BOARD OF APPEALS, CITY & COUNTY OF SAN FRANCISCO

Appeal No. 17-186

The substance or effect of the decision or order appealed from is the ISSUANCE on November 30, 2017, of a Permit to Erect a Building (to erect three stories, no basement, single-family residence) at 2783K Diamond Street.

Case 17-186, 2783K Diamond Street: Single Family Residence,
Appealing Planning Commission Conditions of Approval

NORTH ELEVATION WITH ADDITIONAL STEP

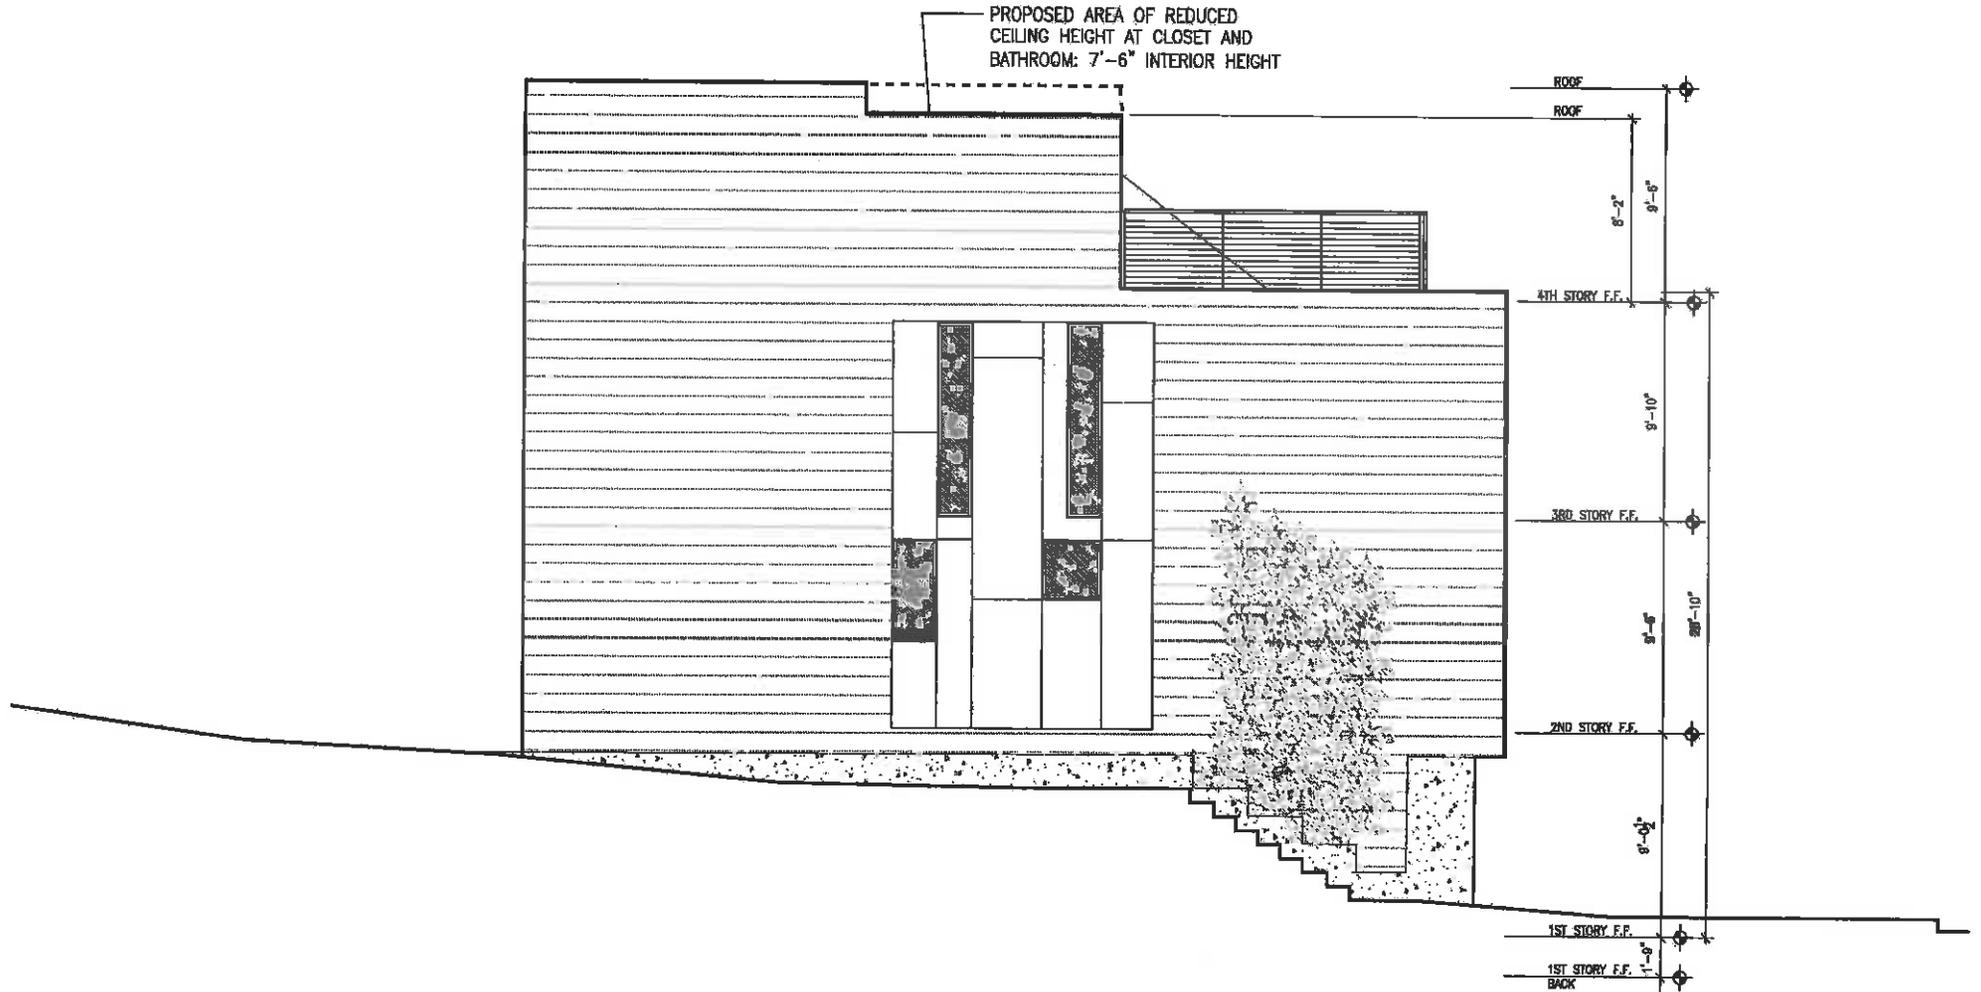
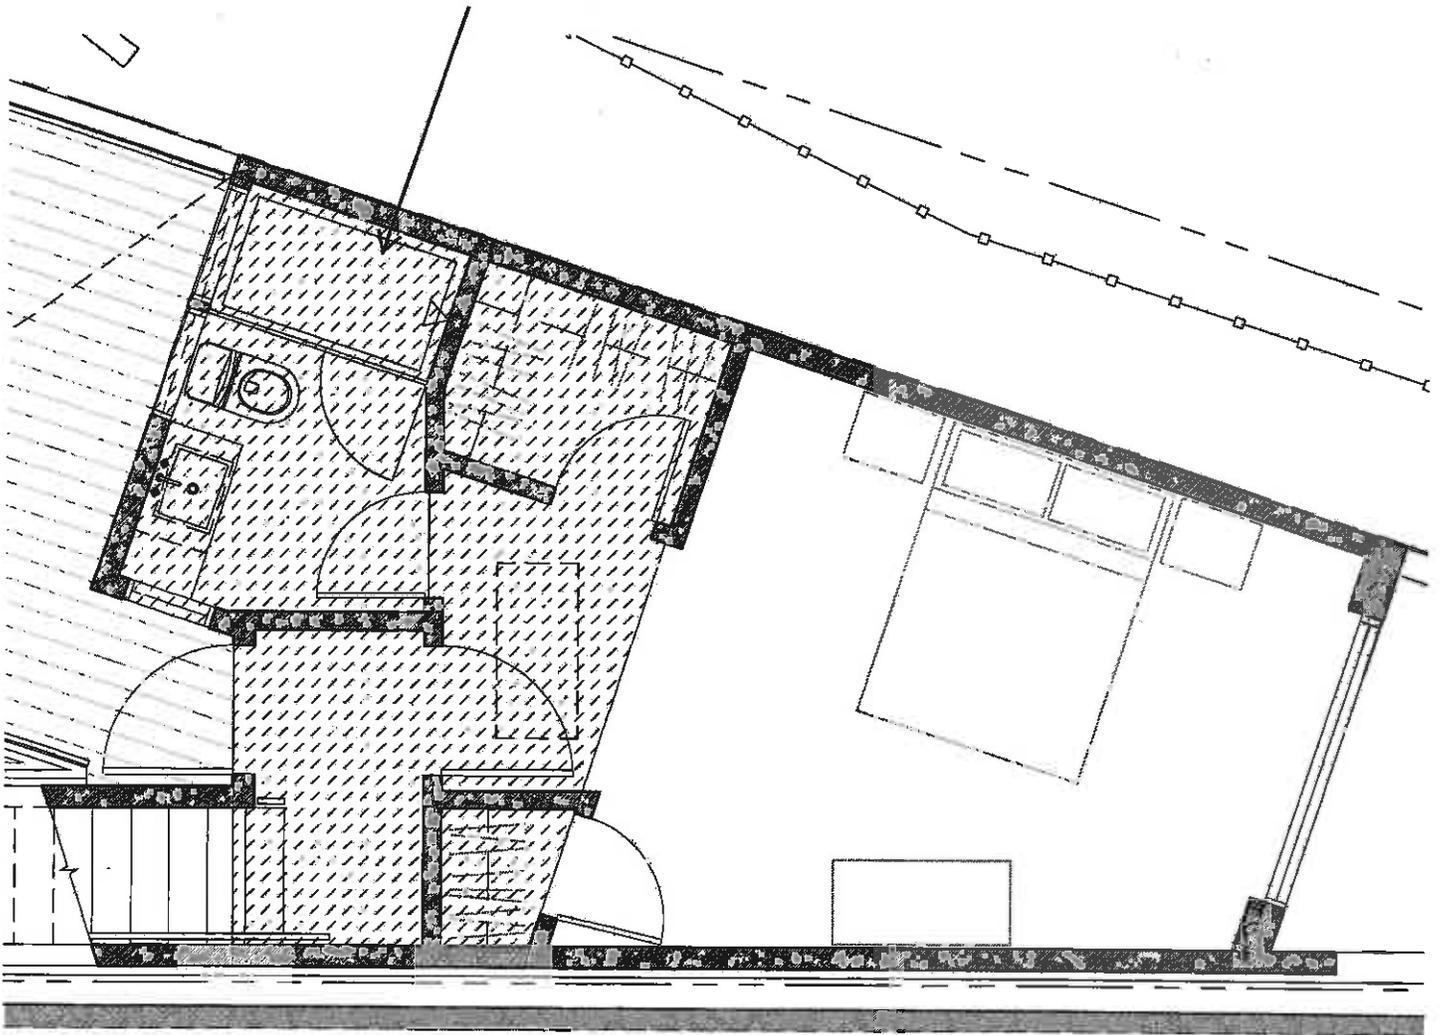
Requested restoration of top floor.
possible area reduced volume at front
of

EXHIBIT 15

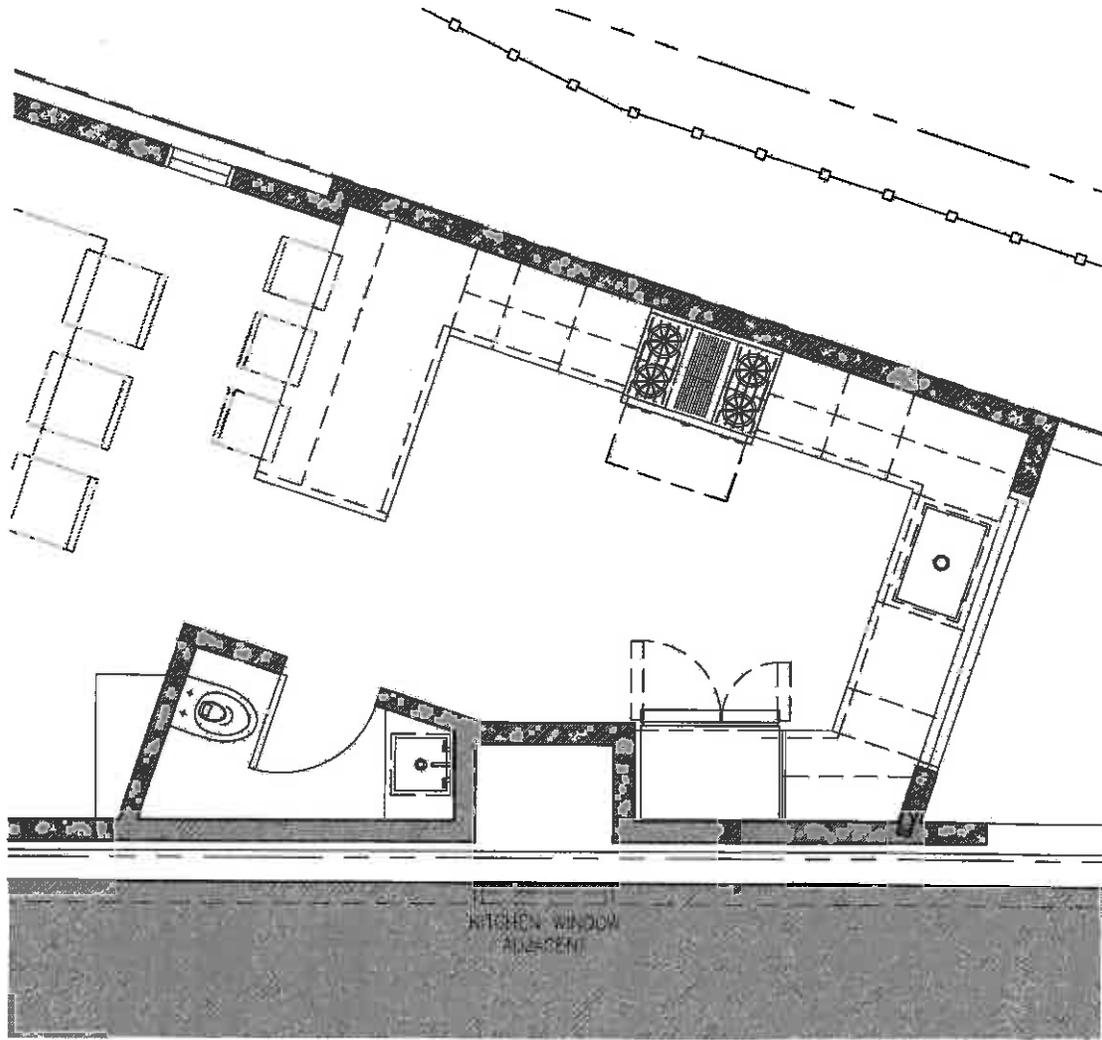
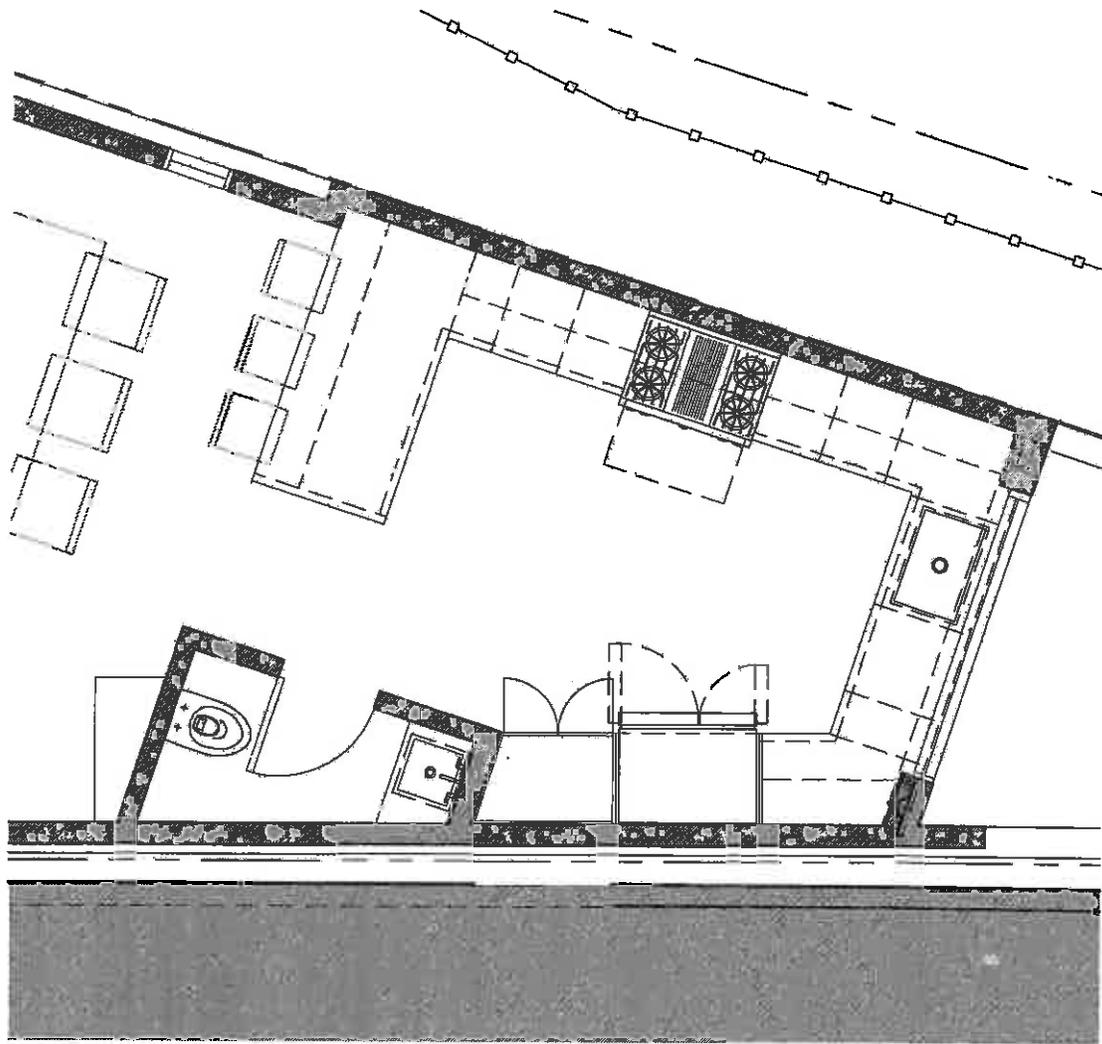
The lightwell requirement is a hardship, creating a notch in an already challenged interior space (See exhibits 15 and 16). The kitchen floor plan is impacted, reducing the amount of counter space, eliminating a location for needed cabinetry and storage. The bedroom floor plan is impacted creating a point of constriction, taking a bite out of a bedroom that is already challenged in terms of the shape and functionality

EXHIBIT 5

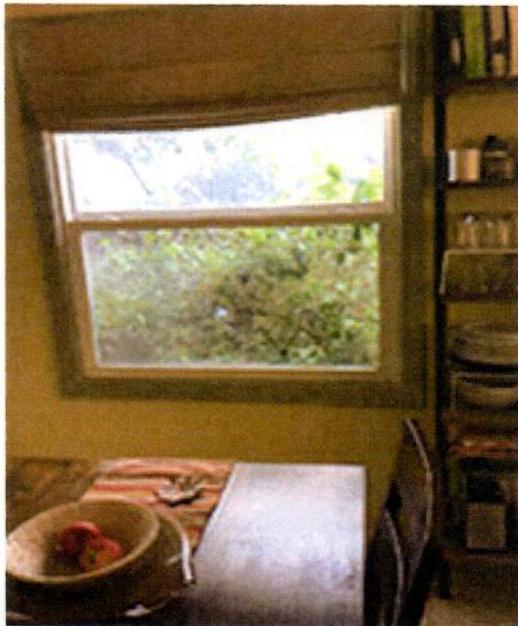
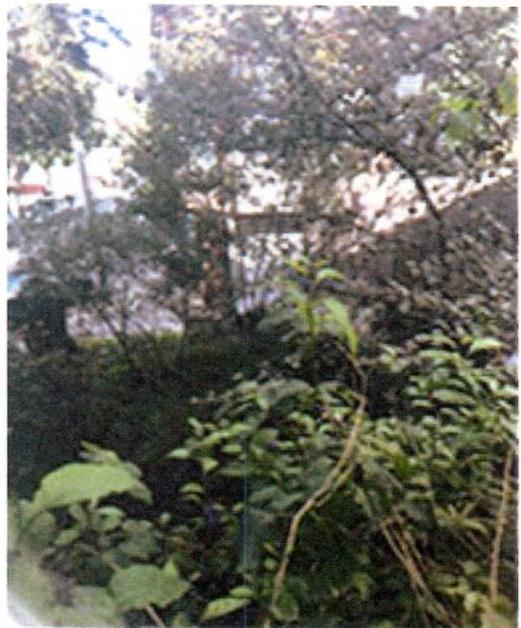
Kitchen windows
from the outside

kitchen windows from the inside looking out

EXHIBIT 6

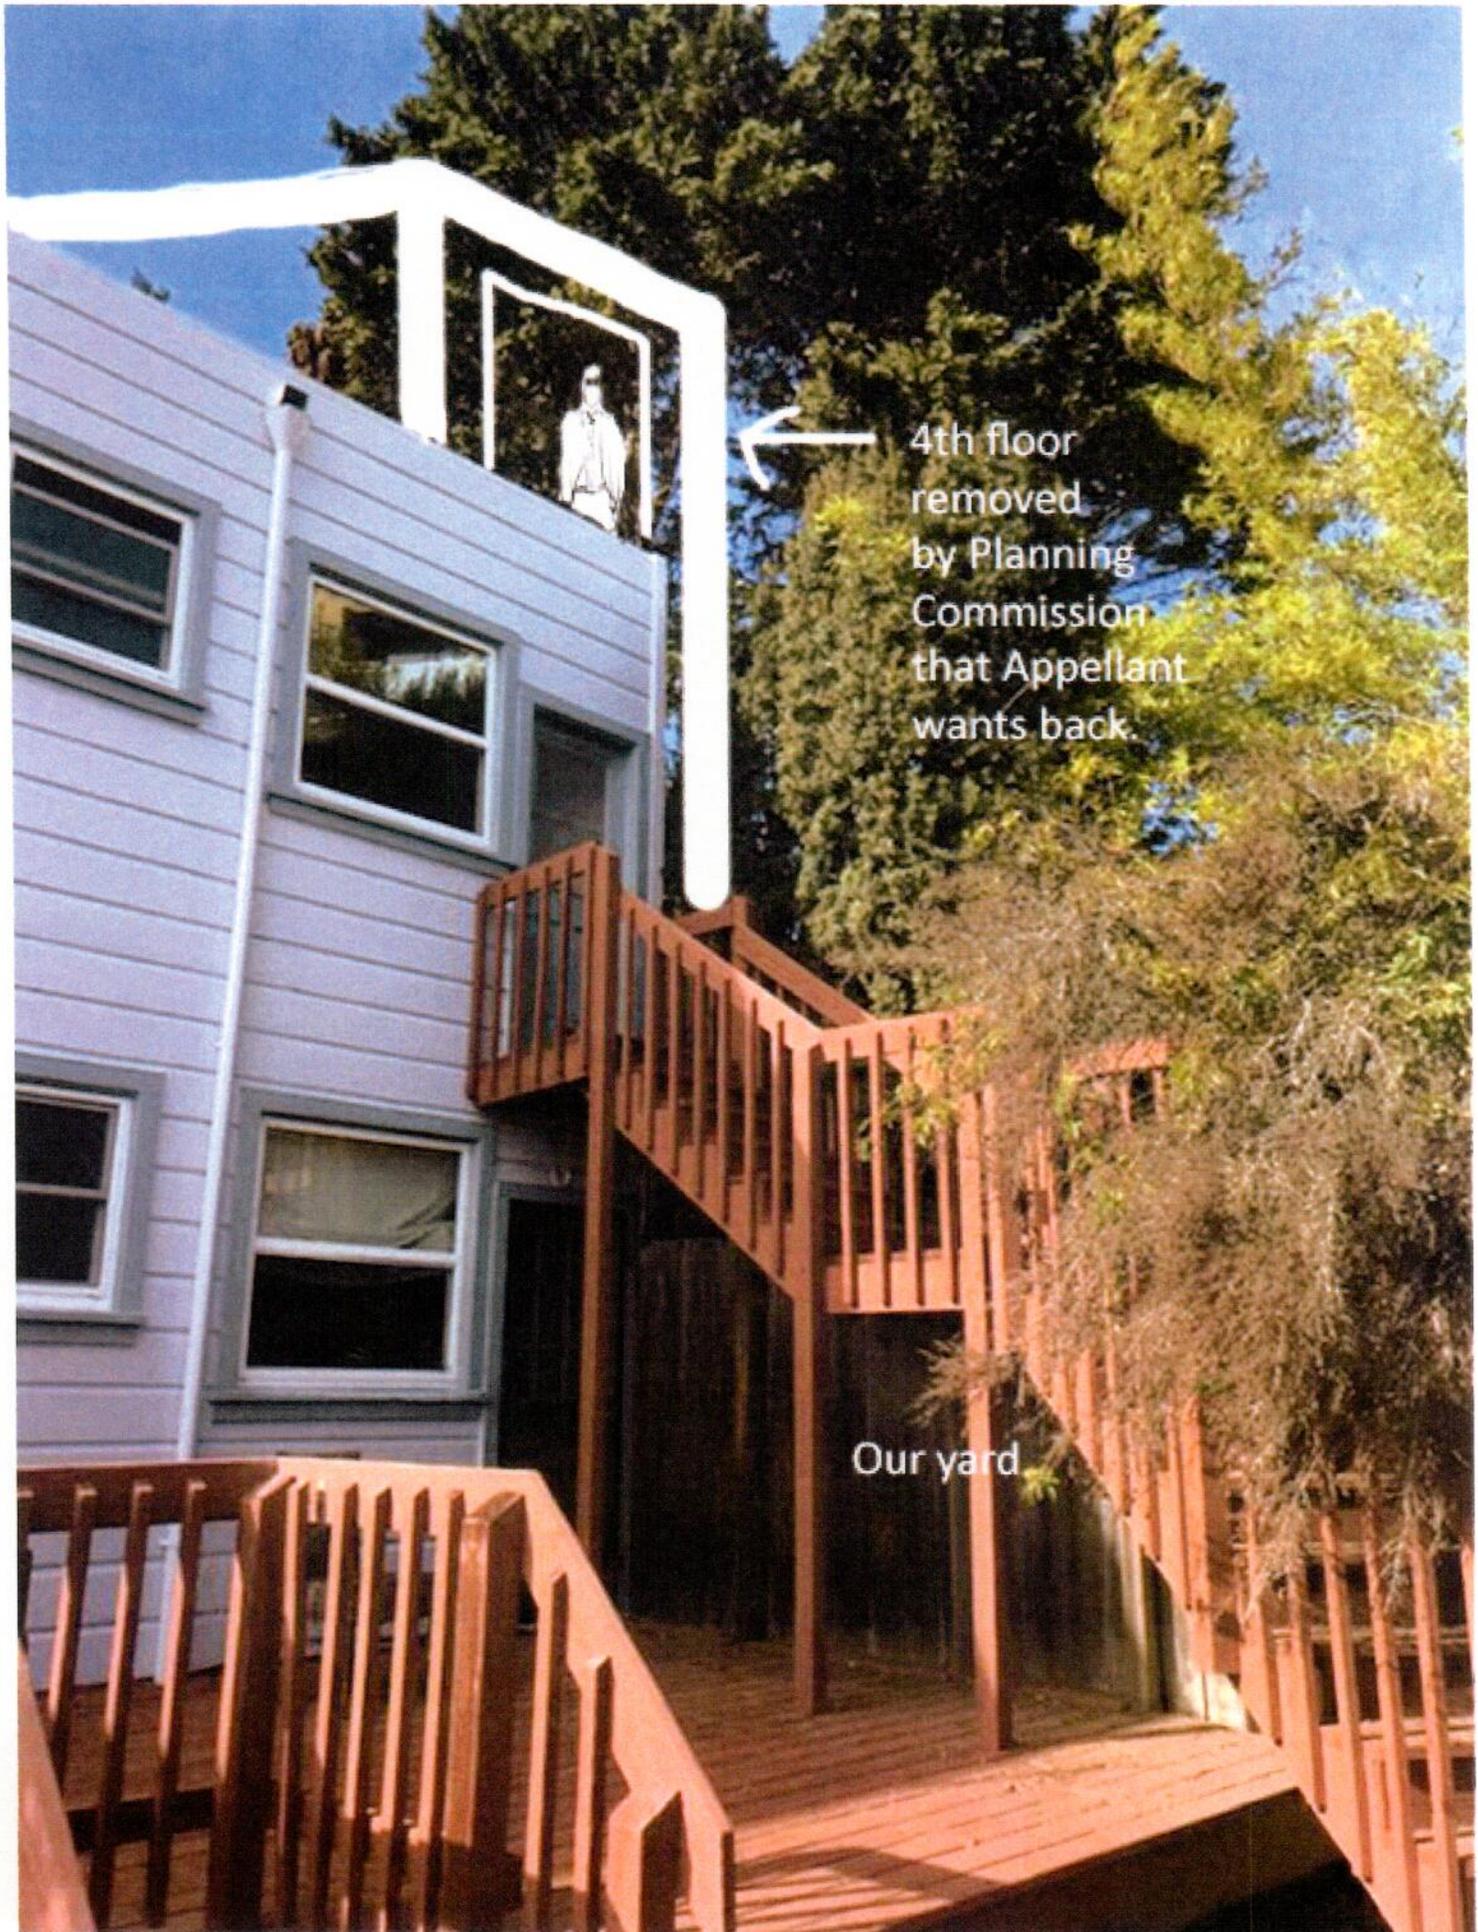
The perceived massing of a 4th floor from our back yard and adjacent back yards will be overwhelming (Exhibit 6). The building will already overwhelm the public steps. A 4th floor – which will block morning sun – will turn the steps into a dark and foreboding niche instead of a light and airy one (please look at Exhibit 2 again and imagine a 4-story wall against the steps). If the sponsor believes he needs more square footage he should purchase a standard-sized lot or he can remove the garage and replace it with bike parking because this site is only a short walk to BART. The proposed garage also creates a crazy conflict in garage access/egress lanes between his new garage and the existing garage at 2783 Diamond. The two properties will be SHARING THE SAME CURBCUT but coming into and going out of their respective garages at almost a 90-degree angle to each other across the sidewalk. It is obvious this is likely to cause both vehicular and pedestrian conflicts (Exhibit 7, site plan showing single curb cut). If additional rooms are needed, what makes the most sense is for the garage to be removed and replaced with the bedroom, bathroom and closet he wants on a 4th floor.

← 4th floor removed by Planning Commission that Appellant wants back.
